**CITY OF TORRANCE, CALIFORNIA**

**ADDENDUM NO. 2**

**PROPOSAL, BOND AND AFFIDAVIT FOR CONSTRUCTION  
OF THE  
TORRANCE TRANSIT PARK AND RIDE REGIONAL TERMINAL, FEAP 764  
B2017-39**

**I. RESPONSES TO BIDDERS' REQUESTS FOR INFORMATION (RFIs)**

- 2) Reference part of Drawing Sheet EY600 (see next page).

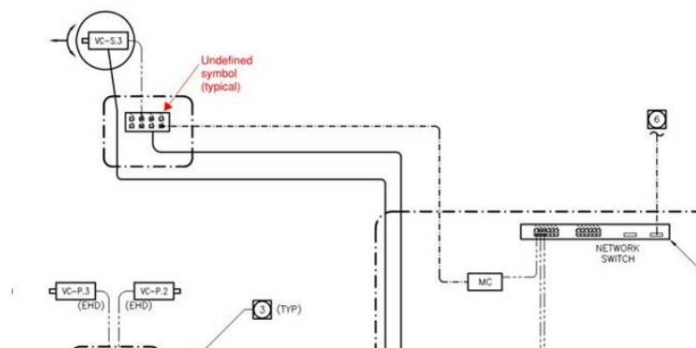
There is an undefined symbol on the single line drawing. Is this a hardened network switch? Is it to be provided by the City IT (like the other network hardware)?

**A6b:** The referenced device in the drawing attached to the Bidder's RFI (partial, marked up portion of plan shown above) is a hardened outdoor rated switch. It is specified in Section 282300, Article 2.2, Paragraph B.
